FINAL REPORT

QA/QC Assessment of Walton County, Florida LiDAR Dataset Produced by Sanborn Mapping

**NOAA CSC Contract EA133C05CQ1048
Task Order No. T007**

February 5, 2007

Figure 3: DEM (Tile 509) color coded by elevation illustrating the height offset between adjacent flight lines.

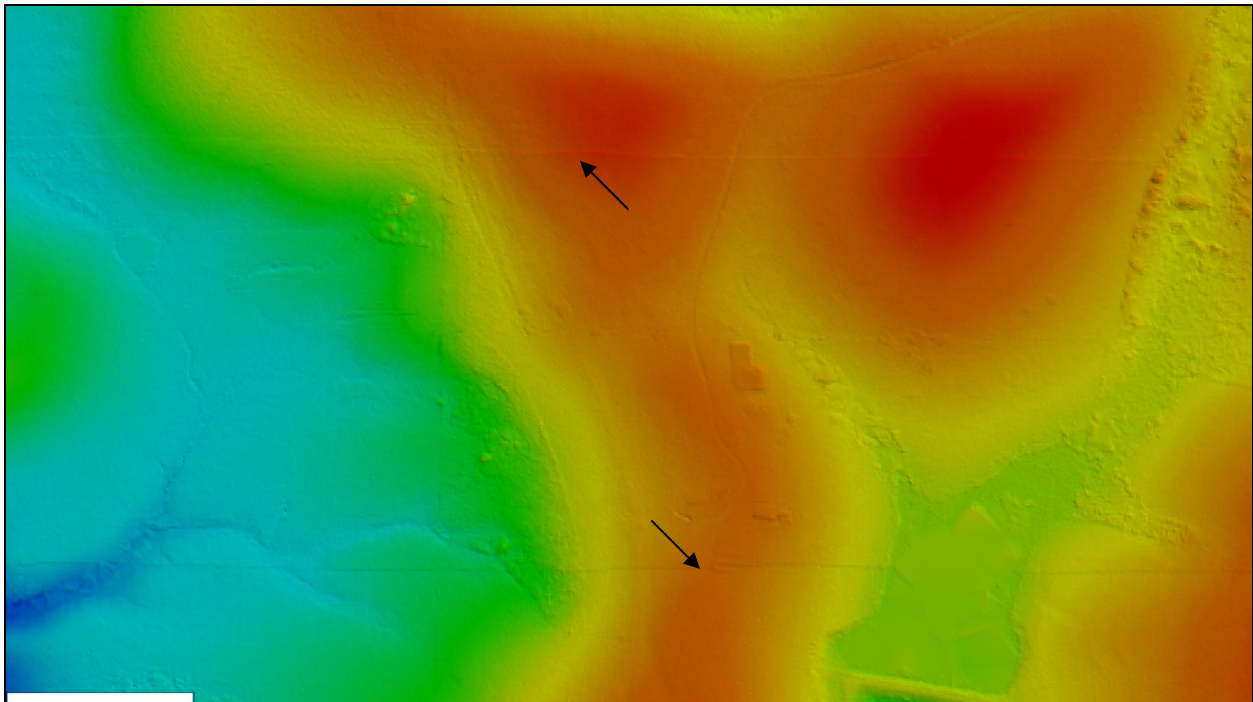
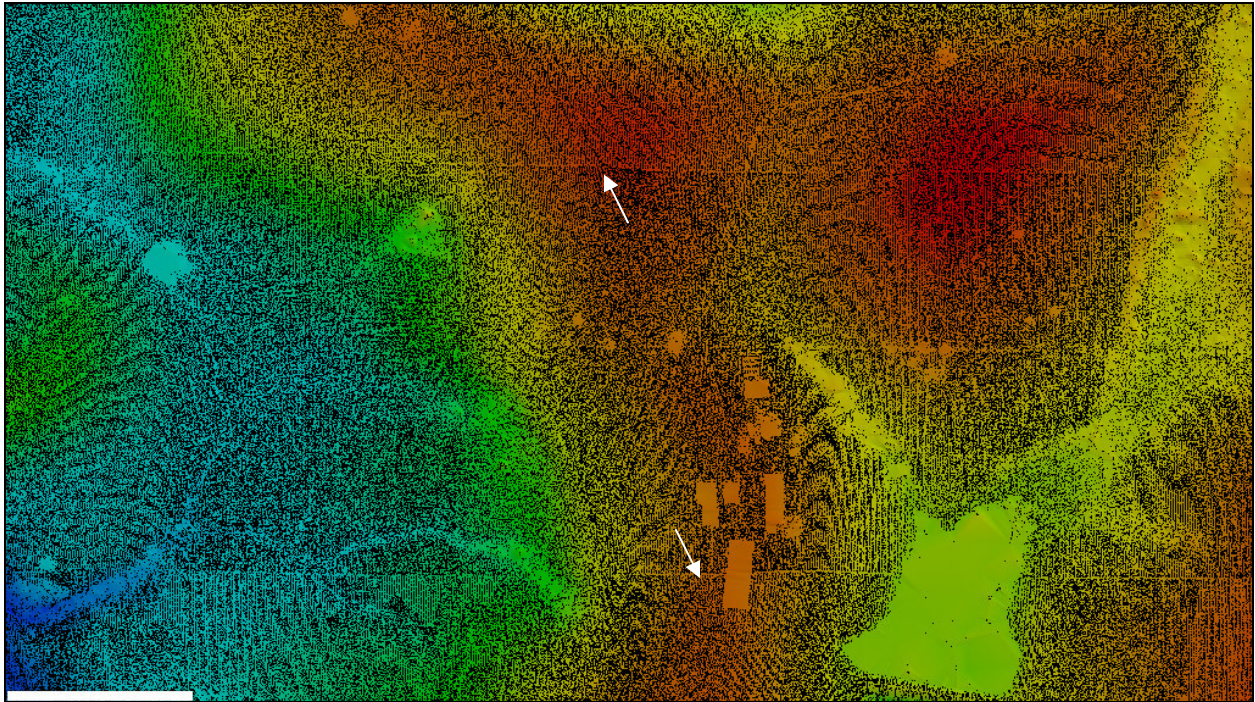
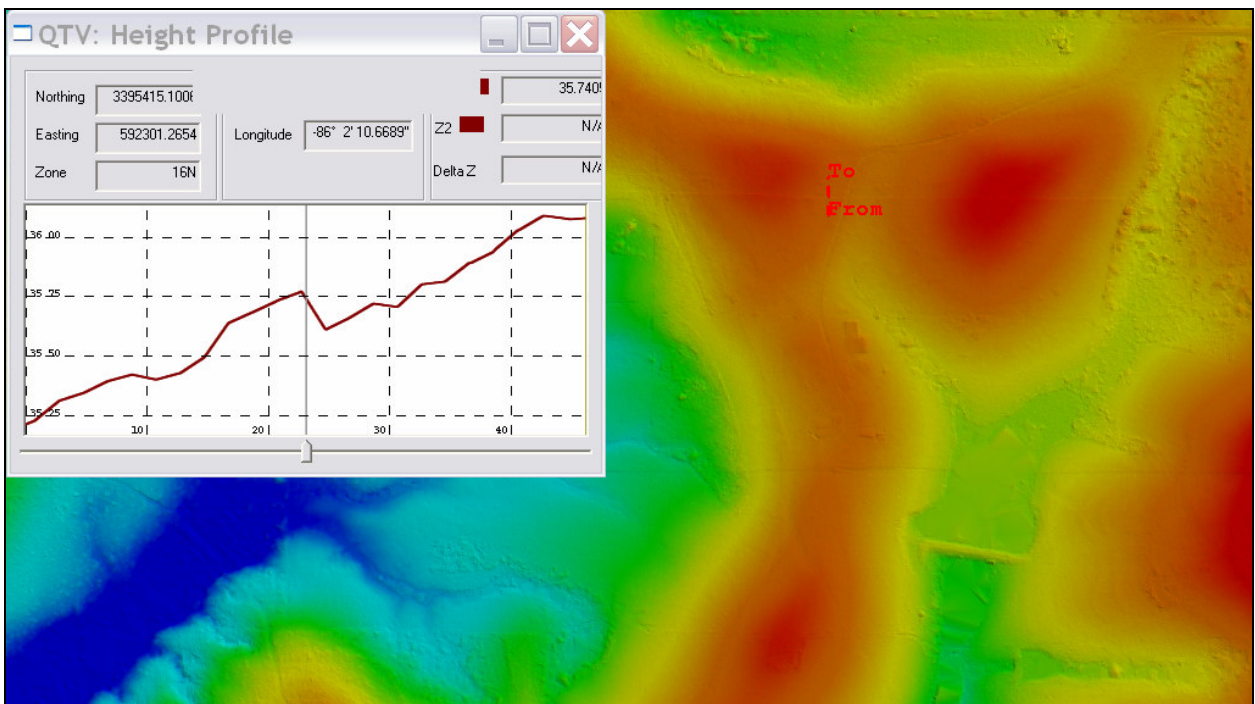
The lidar data contained sporadic issues such as artifacts or small anomalies which is typical of any lidar dataset. However one issue that was repeatedly found throughout the dataset is a phenomenon we call “edge match” issues. Edge match issues are caused by defining a seam line between adjacent areas and removing points from overlapping scans. This in effect joins one scan to the next with no overlapping areas while also reducing noise. Some processing techniques include removing points from both scans along the defined seam line. The edge matching issues found in this dataset seem to have been a result of a different methodology. It appears that overlap was reduced between flight lines by removing points from one scan along a defined edge. For example instead of having an overlap of 30% it has been reduced to 10%. However because there is a slight offset between flight lines, this processing technique produces what appears to be a seam line shift where one dataset is higher than the other at the edge of the reduced overlap. In most cases the data is of excellent quality and the adjacent data matches quite well, but there are areas where it does not match to the same high level of accuracy. Figure 3 illustrates a DEM that includes an edge match issue where it is easy to see the offset between the center flight line and the neighboring flight lines to the north and south. Figure 4 illustrates the same tile but with the mass points visible revealing the edge where the two scans were merged. Figure 5 illustrates a cross section perpendicular to the seam line. In this example the offset is approximately 12 cm which is the average offset difference found in the data.

Figure 6: DEM (Tile 547) displaying edge match issue.

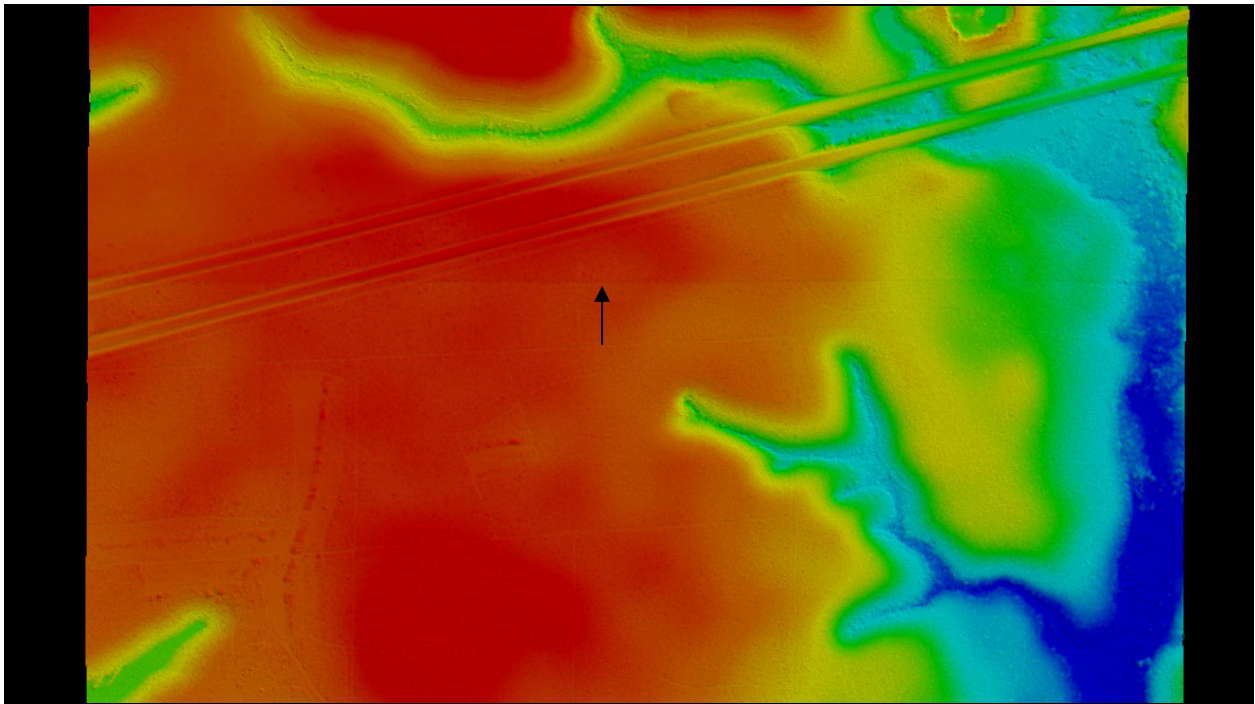
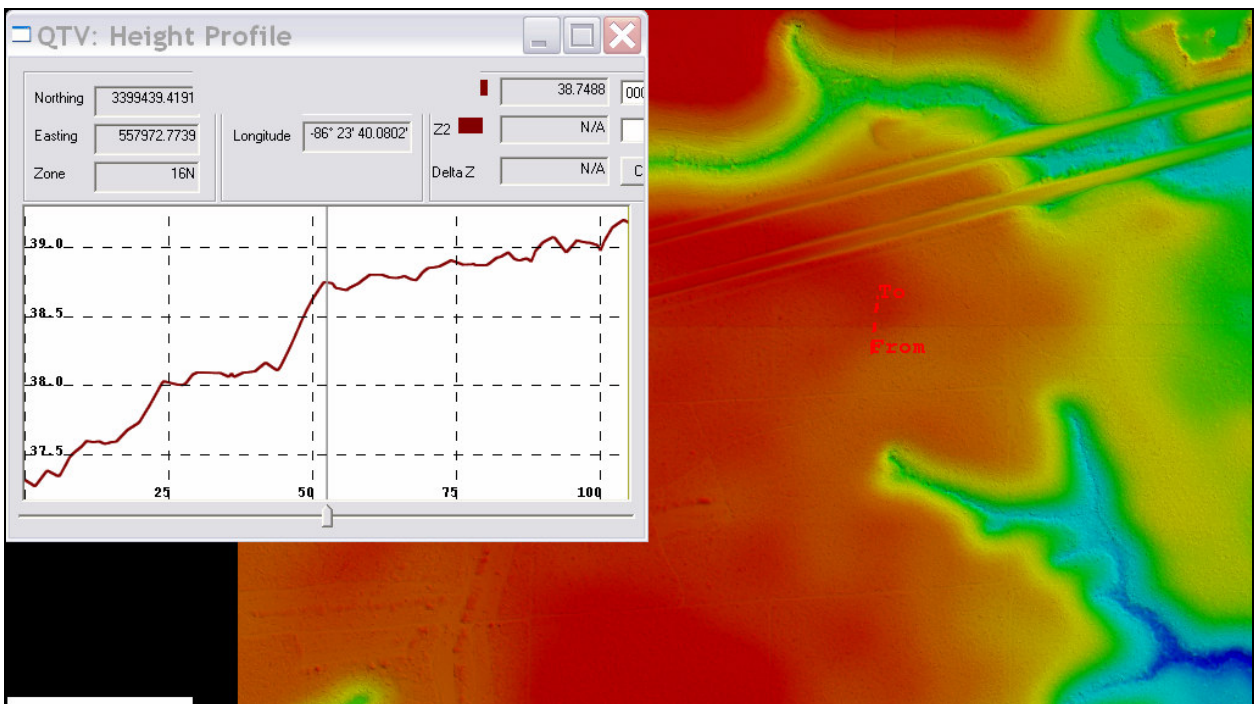
Although similar edge matching issues were found sporadically throughout the dataset and in some cases across multiple tiles (Figure 8), this does not indicate that the data are of poor quality. An offset of 12 cm is small enough to retain good relative accuracy between flight lines and the checkpoint survey validated the vertical accuracy. There were a few instances however where the offset was as high as 50 cm (Figures 6 and 7) and further investigation is recommended.

Figure 9: DEM (Tile 726) illustrating "Cornrow Effect"

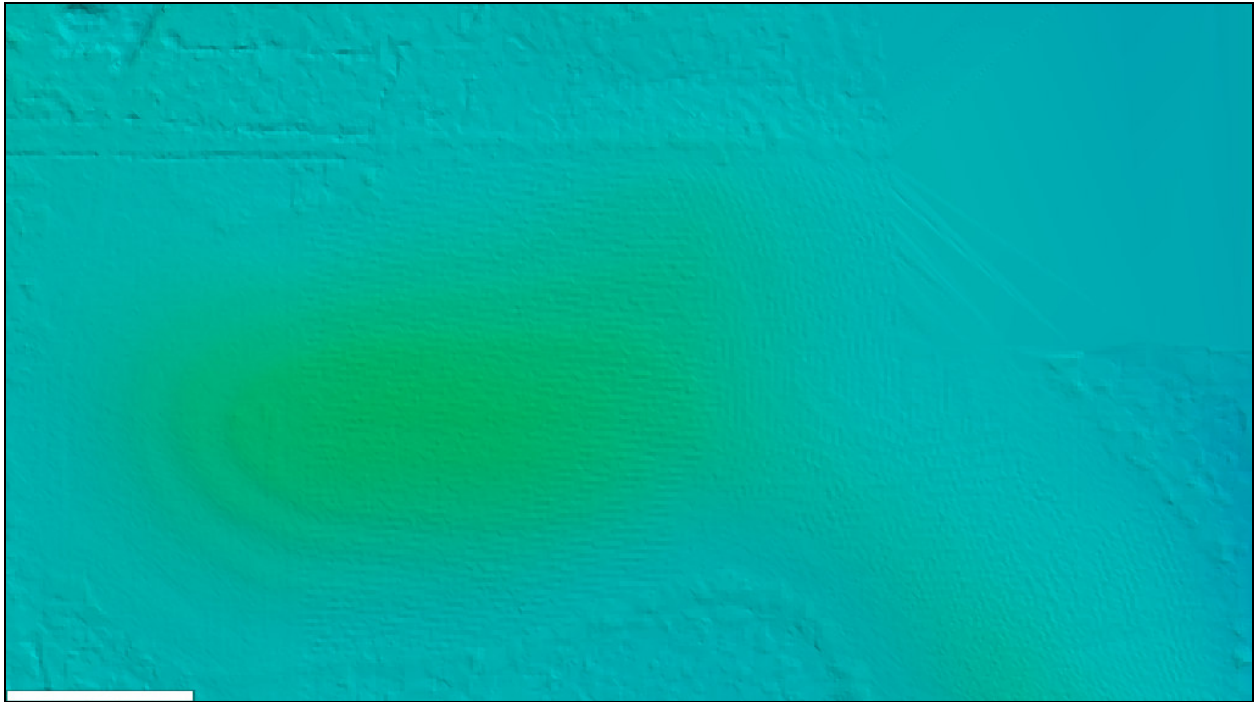
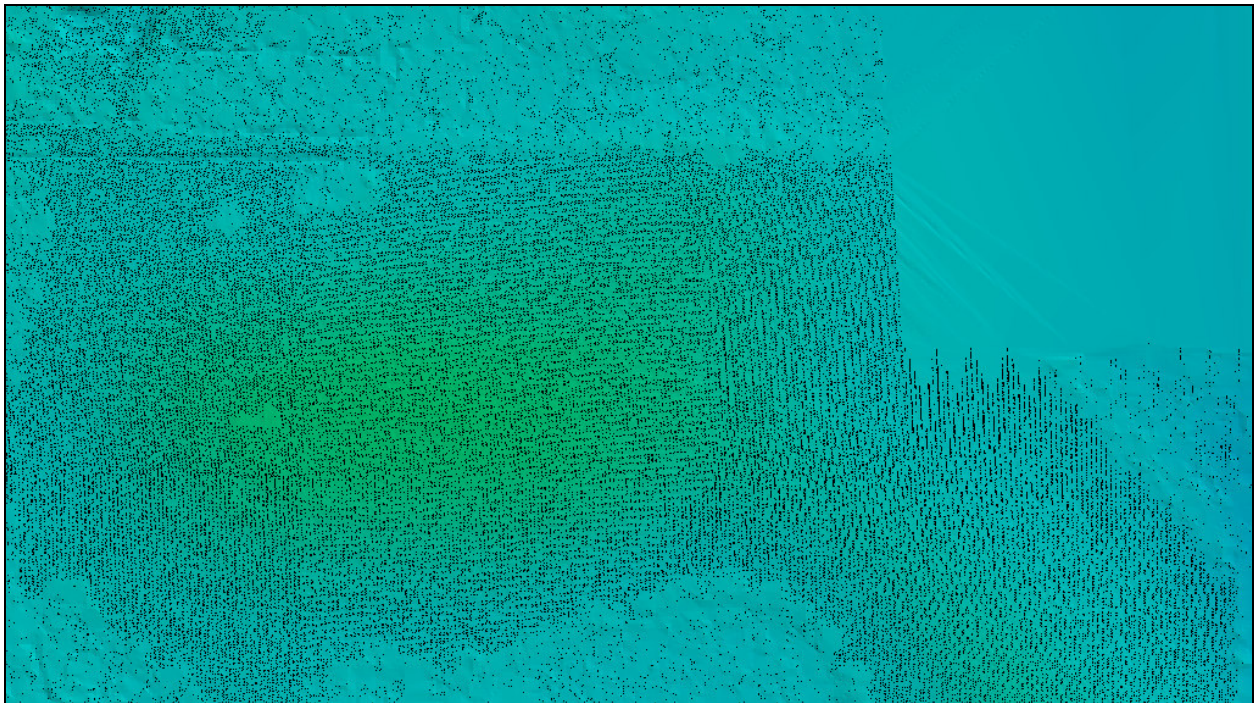
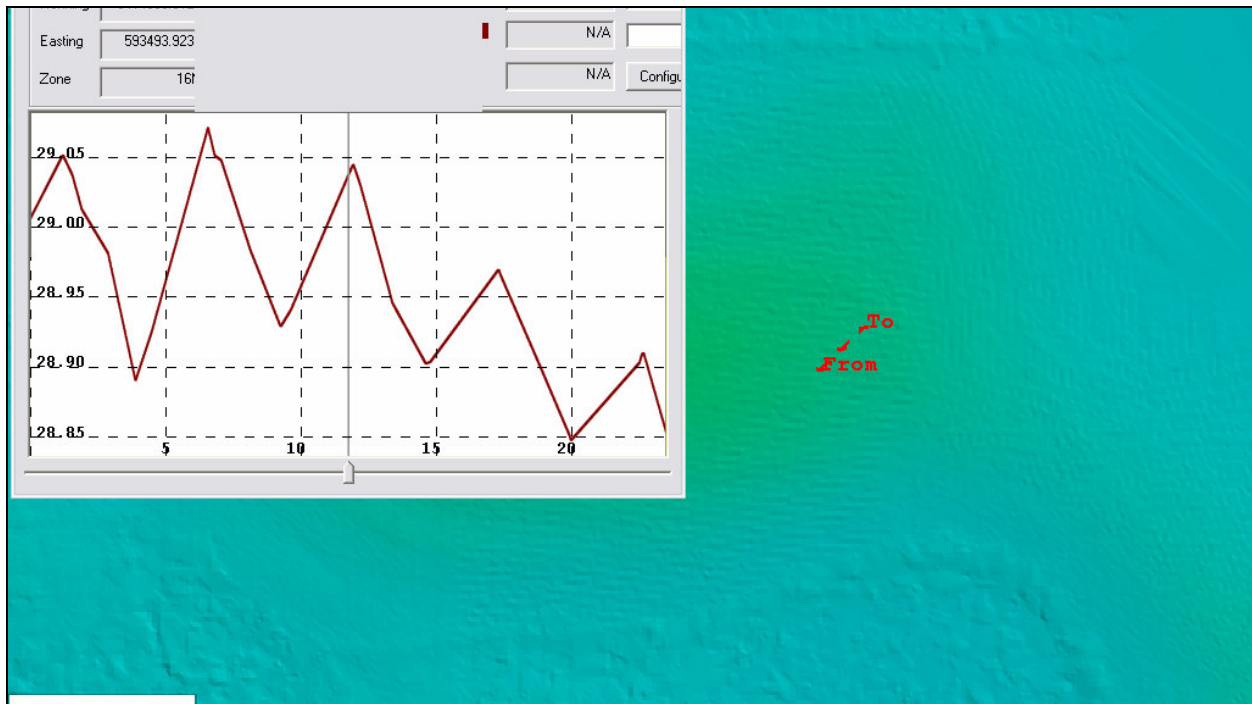
Another issue that was found intermittently throughout the project area is a problem called the "cornrow effect". There are a few different schools of thought on what causes this phenomenon but one of the most common is a problem with the sensor itself. It is believed that the sensor loses sync during turbulent flight conditions causing the forward and backward rotations of the mirror to be at two different elevations, producing a high-to-low furrow effect resembling crops in a field. This affect can also be found in areas of overlap between two adjacent flight lines that have slightly different vertical elevations typically caused by a weak GPS solution. Although this phenomenon is found frequently throughout the dataset, the differences in elevation are not large enough to have a significant effect on any anticipated modeling. Figures 9, 10, and 11 display examples of cornrows found within the data.

Figure 11: DEM (Tile 726) with cross section drawn across corn rows. The elevation differences vary between 6 and 17 cm.

Figure 12: DEM (Tile 75) illustrating divot.

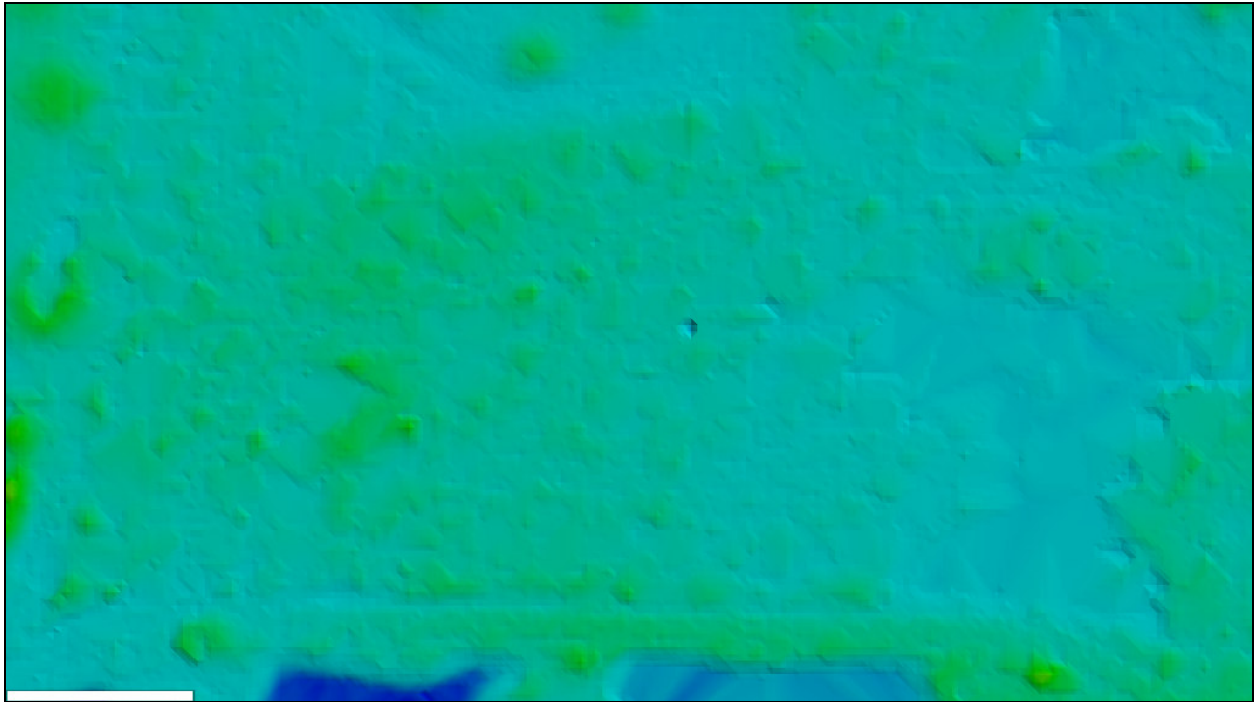
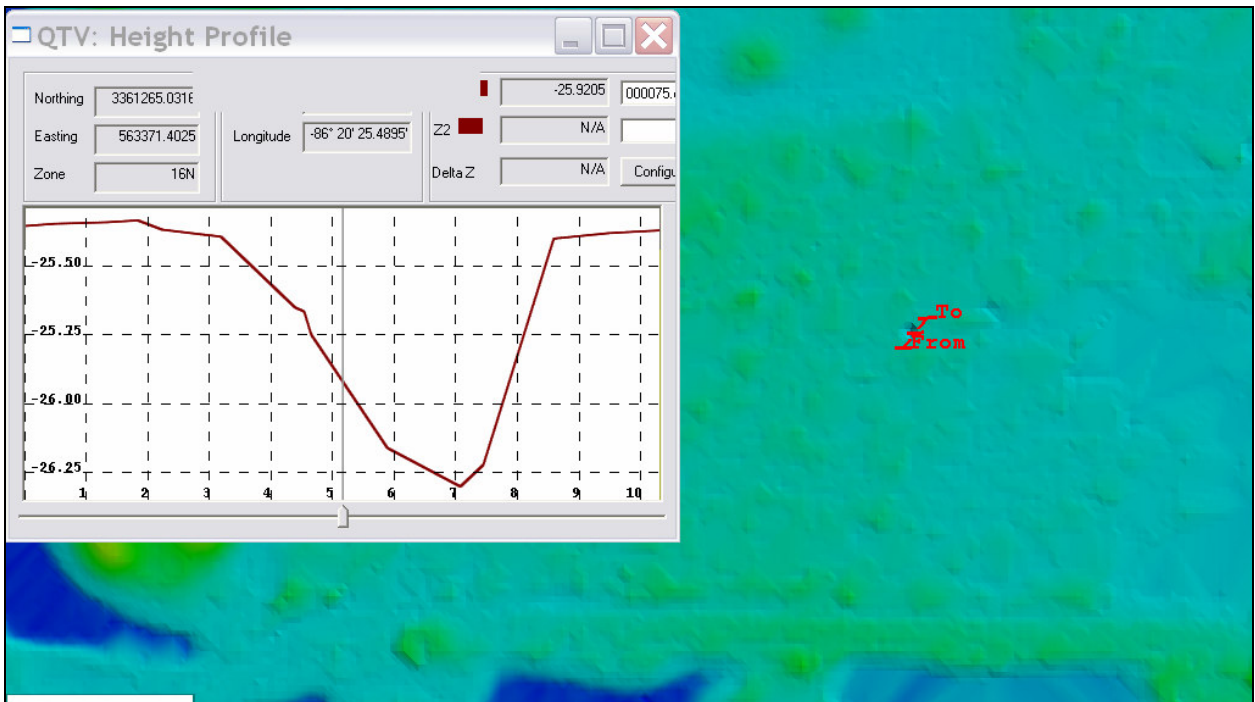
Overall the level of cleanliness for this product is excellent and meets the guideline for lidar to be generally clean of artifacts. At times though the classification process can be in error and minor issues are presented. There were a few sporadic instances where buildings were not completely removed during the classification process and sharp edges could be seen in the data (see Appendix A). One issue that was found throughout the dataset was the presence of divots. These are caused by one or more “low” points that were left in during the classification process, producing what looks like a hole in the terrain (Figures 12, 13, and 14). There were quite a few divots found in the data most of which were less than 1.5 meters deep. Although considered common for certain types of sensors, these anomalies should be re-examined based upon the scale of the analysis performed on the area in question. While these divots will not have a significant effect on the overall quality of the data, they could affect small scale analysis.

Figure 13: DEM (Tile 75) illustrating cross section of divot. The graph shows that this divot is approximately 75 cm deep.
